# CONVAIR

## COMMERCIAL CHANGE PROPOSAL

SPEC NO.: ZD- 22-003

MODEL: 22-2 (Convair "880")

MOD 22  
 MAIN WHEEL  
 EMERG BRAKE  
 STORAGE PRESSURE  
 VS  
 APPLICATIONS  
 (USED OR REMITTING)  
 (APPL & FULL BRAKE APPLICATION  
 AT 900 PSI)

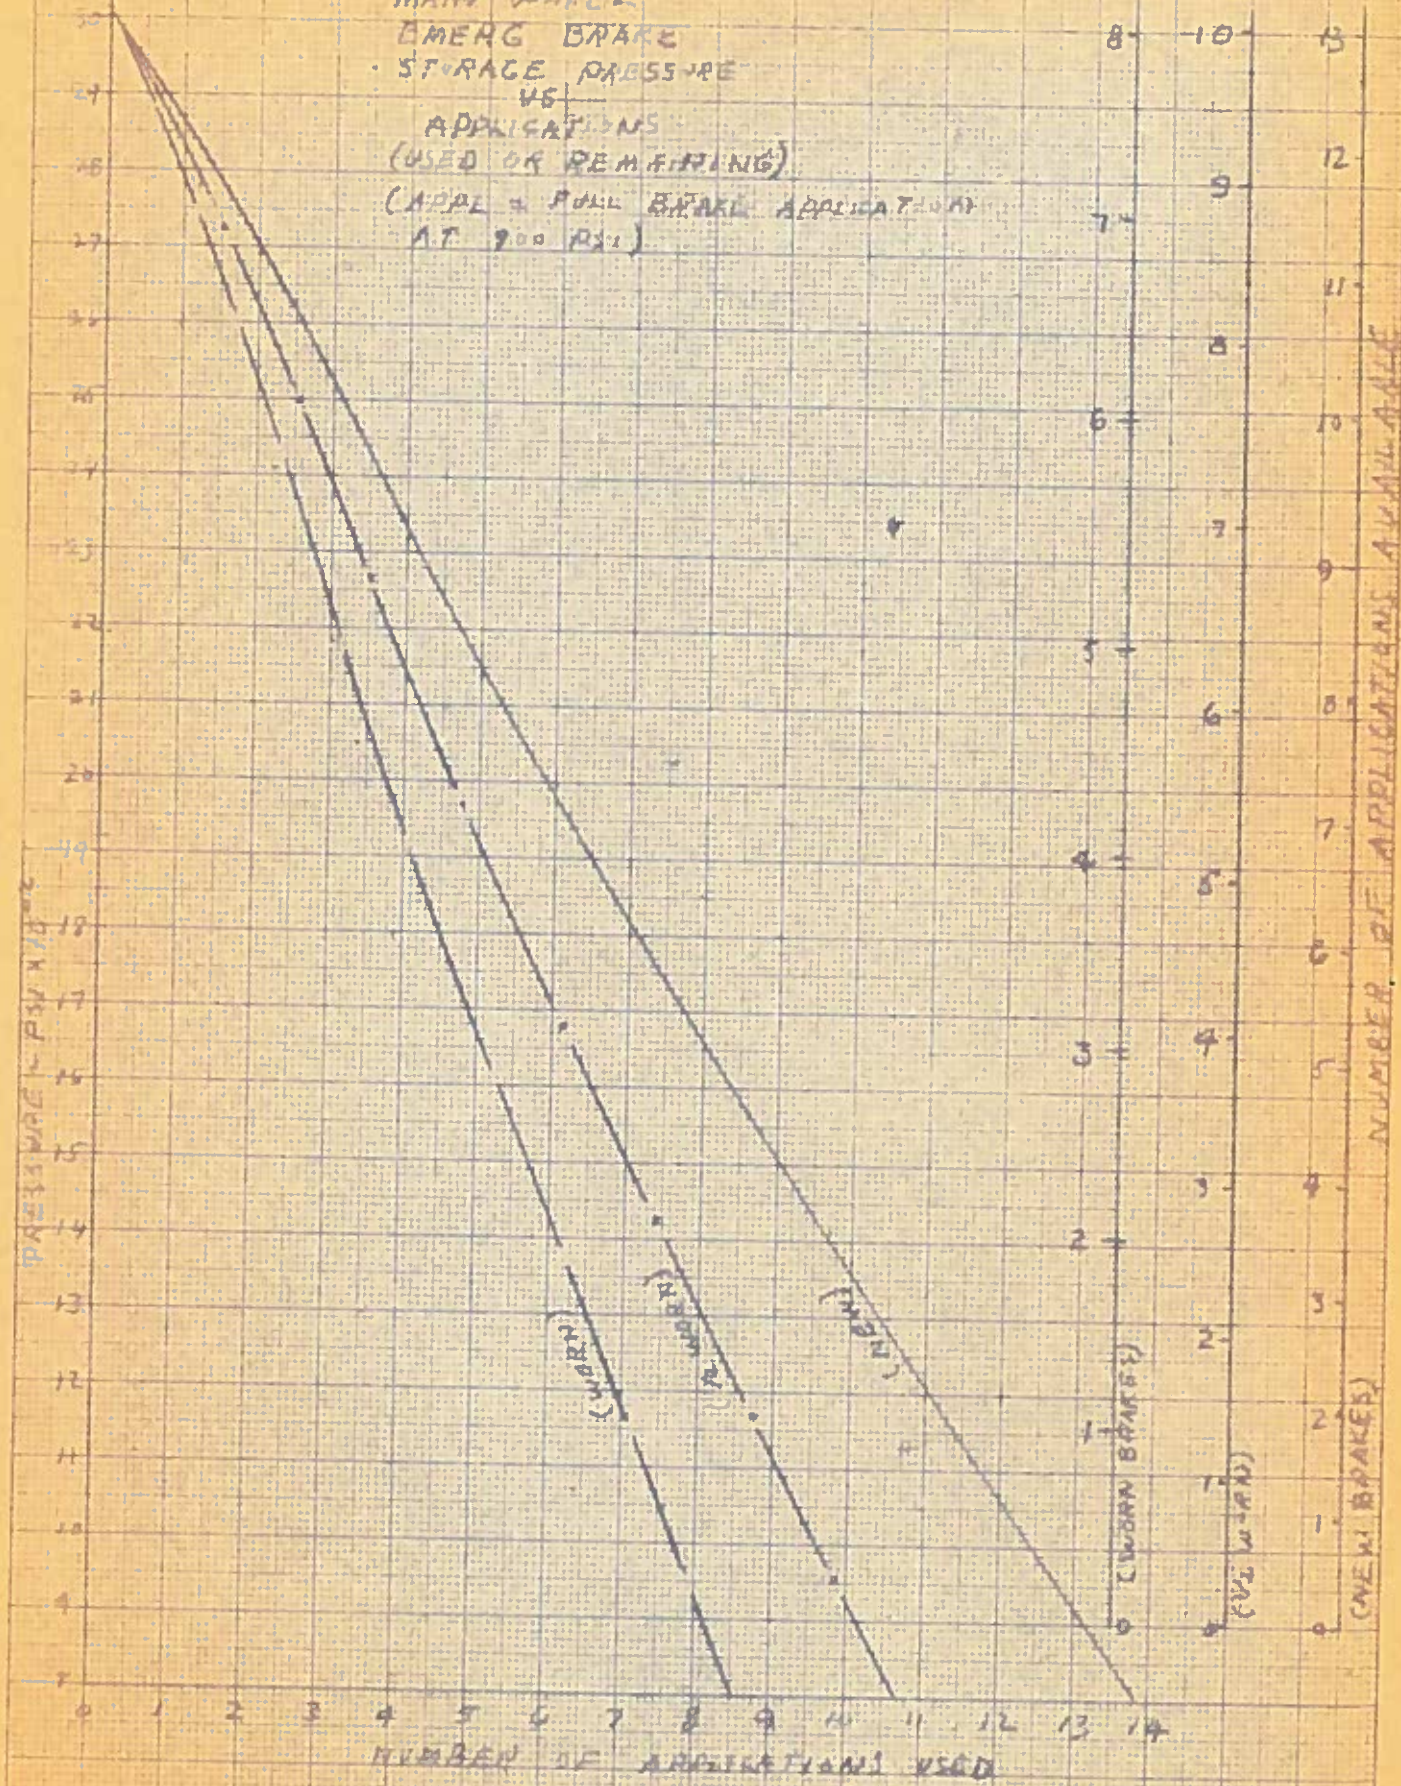
Reason for Change: Replacement of the fiber glass air flask  
(2,200 psi) with the ICC steel flask  
(3,000 psi) made it necessary to reduce  
the cylinder volume from 400 to 300 cubic  
inches.

Green Arc (Operating Range)	1,600 to 3,000 lbs
Red Line (Maximum Charge)	3,040 lbs
Yellow Radial Line (One Application)	*1,200 lbs

- ENCLOSURES: (A) Convair Sketch - HEAD REST, ATTENDANT SEAT, FWD. ENTRY COMPARTMENT (For information only.)
- (B) Convair Sketch - HEAD REST, ATTENDANT SEAT, AFT ENTRY COMPARTMENT (For information only.)

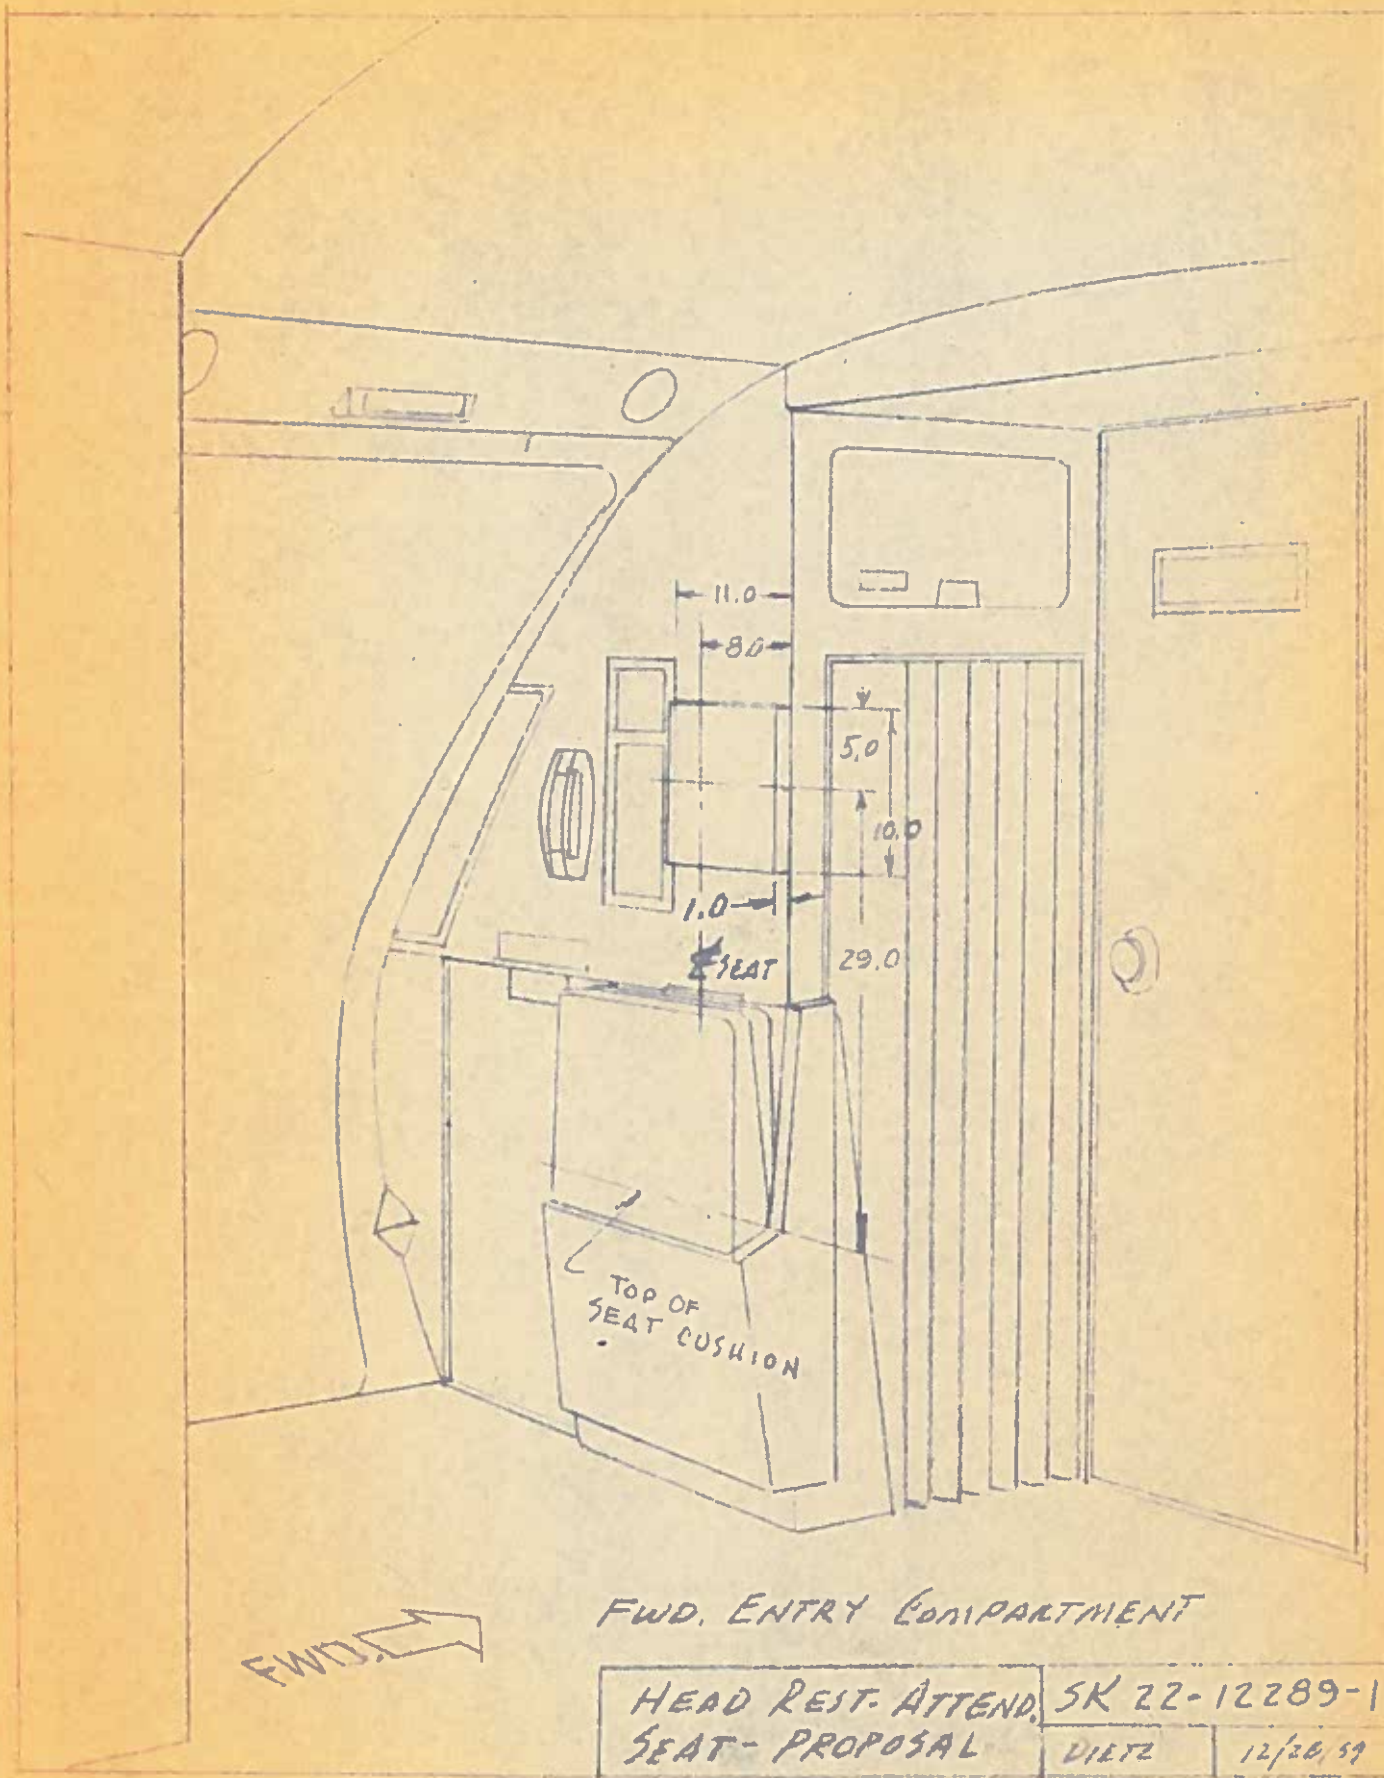
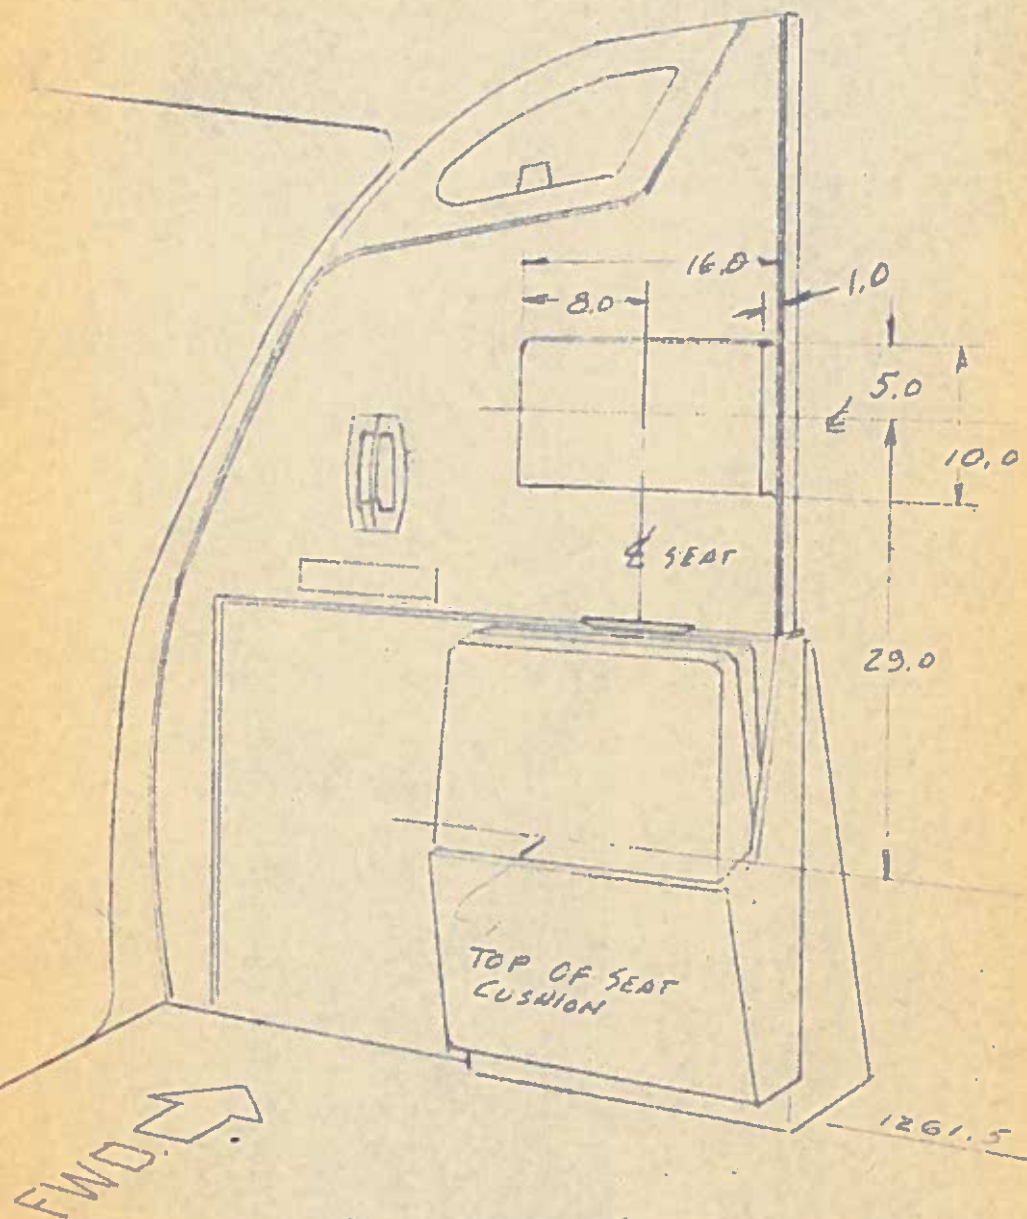
Page 104, Paragraph 3.19.1.1.4 CABIN ATTENDANTS' SEATS:

Add the following to the end of the paragraph:

"An upholstered, detachable head rest shall be installed, one each on the aft face of the forward left hand coat compartment and on the left hand aft bulkhead for use of the aft facing cabin attendants."

Page 12a, CENTER OF GRAVITY LIMITS

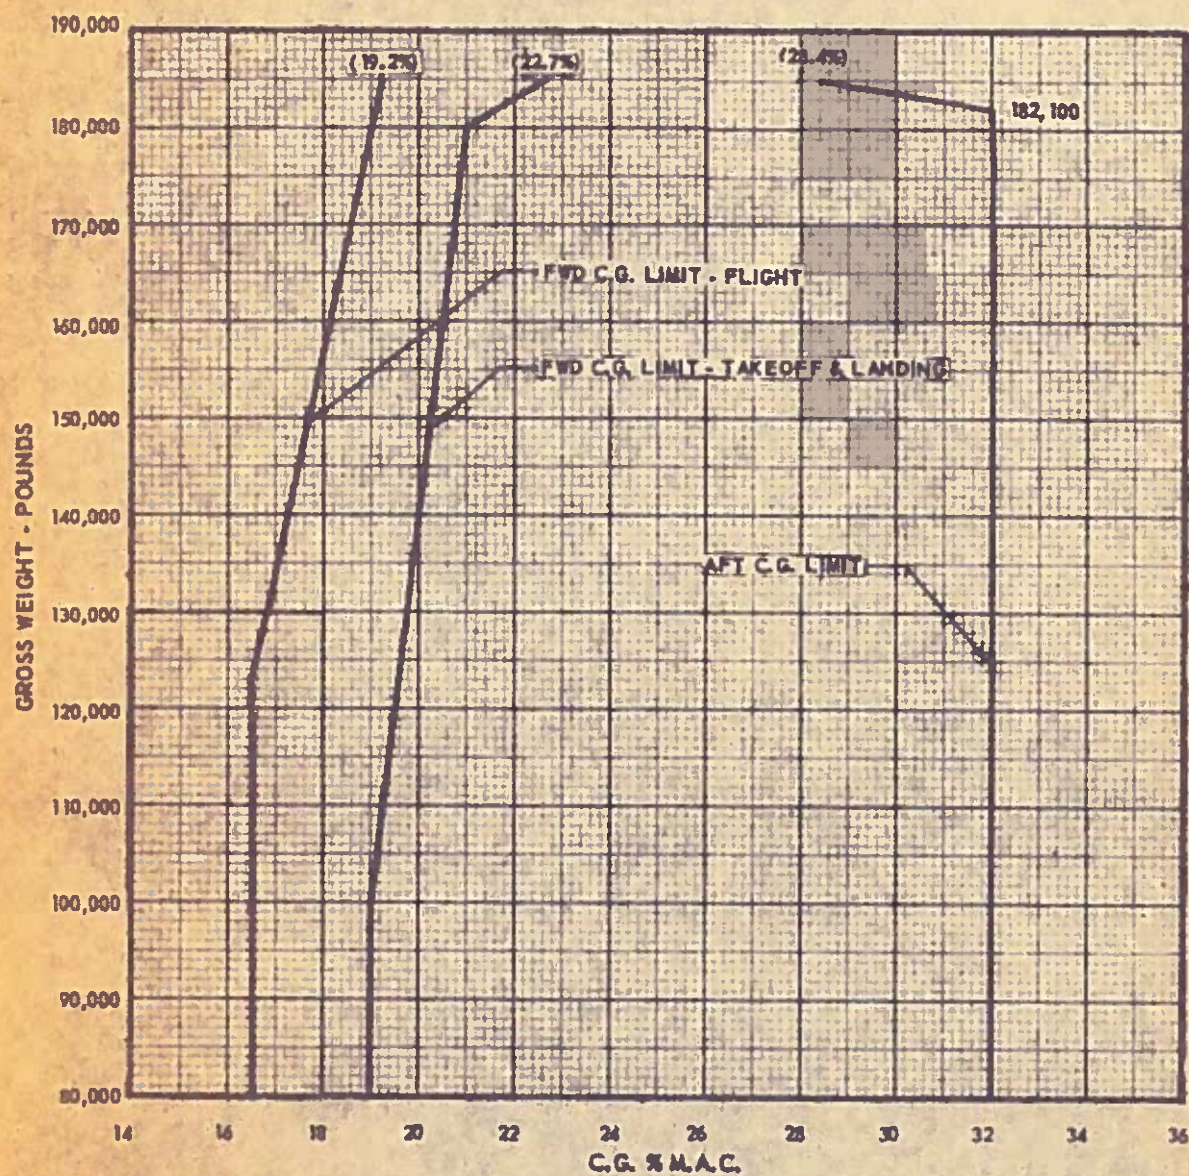
Replace above graph in specification with Enclosure: (A):

Enclosure: (A) One copy Page 12a, CENTER OF GRAVITY LIMITS  
(Revised)
